**ON-SITE SEWAGE DISPOSAL SYSTEM  
 HOWARD COUNTY HEALTH DEPARTMENT  
 BUREAU OF ENVIRONMENTAL HEALTH**

SUBDIVISION: Pindell Woods LOT NUMBER: 18

ADDRESS: 7224 Preservation Court PROPERTY OWNER: Mount View LLC

**WALL CHECK**

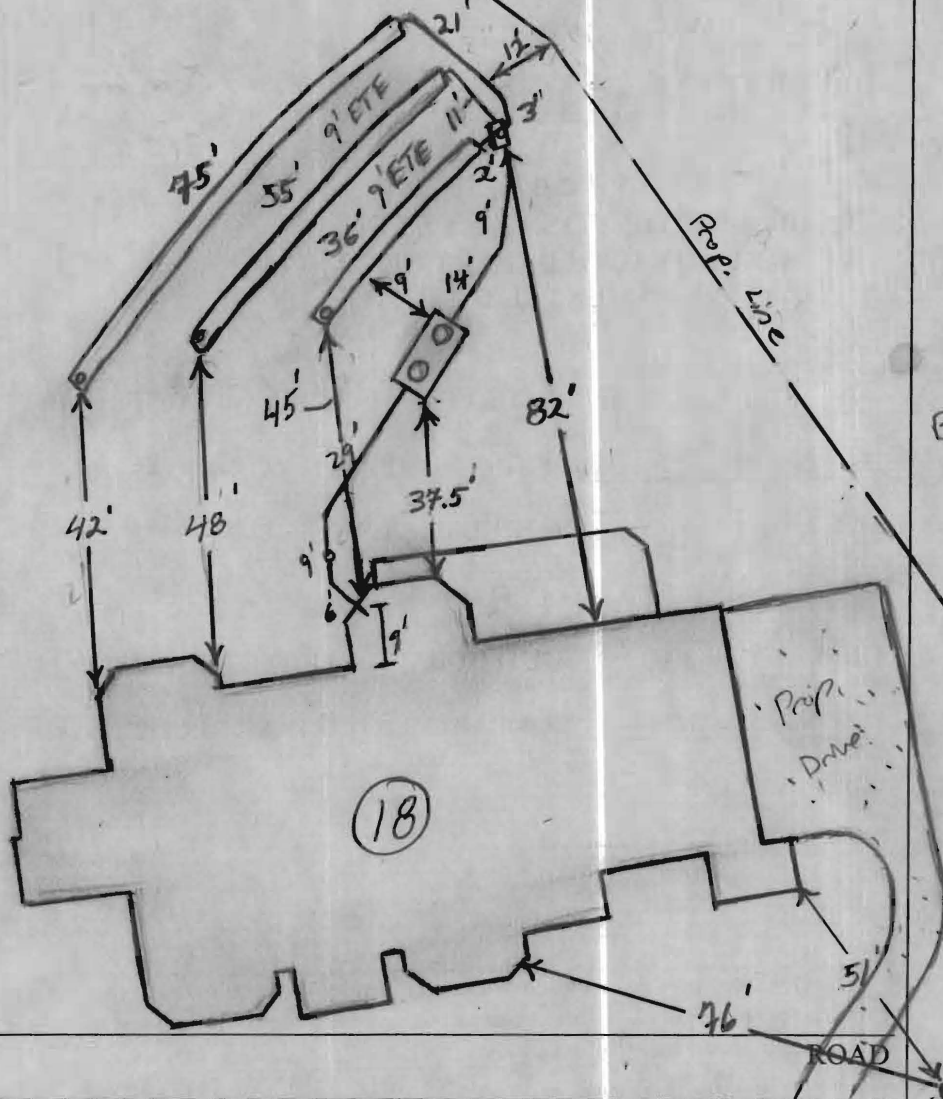
PRE-CONSTRUCTION 9/6/07 Due to the alteration of the house placement, plumbing (including S.T. location) has changed. Keep D box as per INSTALLATION plan, but contractor is to install a 42', 55', 72' trenches or consider laterally across SDA. Keep no more than 3.5' of cover on tanks. Call for insp. (KW) 9/7/07  
 Plumbing installed from house to tank. up to D box. OK to backfill up to D box no trenches. dug. (KW) 9/10/07 (H.M.)  
 Bottom trench dug and stoned. Soil looks good. S.A.M. OK to continue (KW) 9/10/07 (pm) system complete OK for backfill (KW)  
 Contractor to level out D box. (KW)  
 FINAL INSPECTOR J. Wolf DATE OF APPROVAL 9/10/07

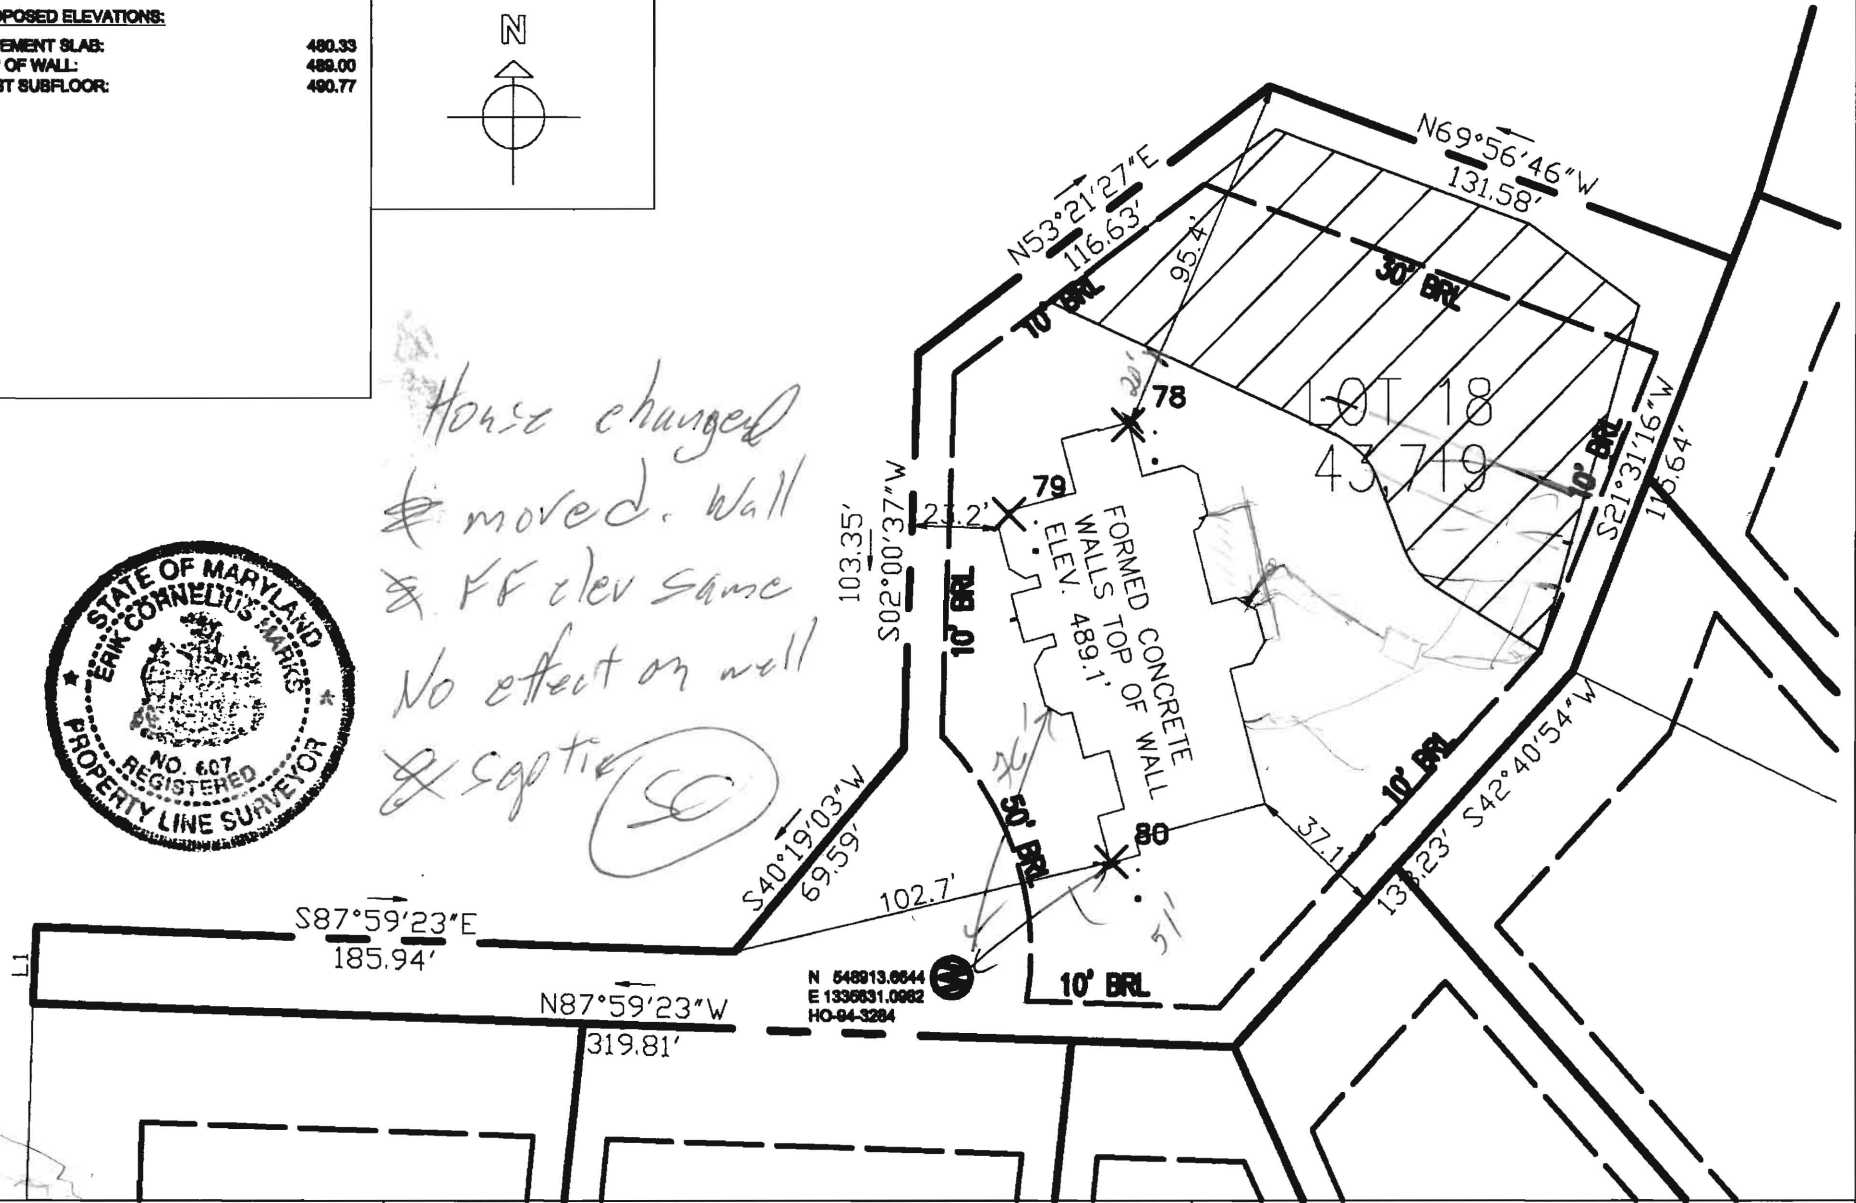
*House changed  
& moved. Wall  
& FF elev same  
No effect on well  
& septic*
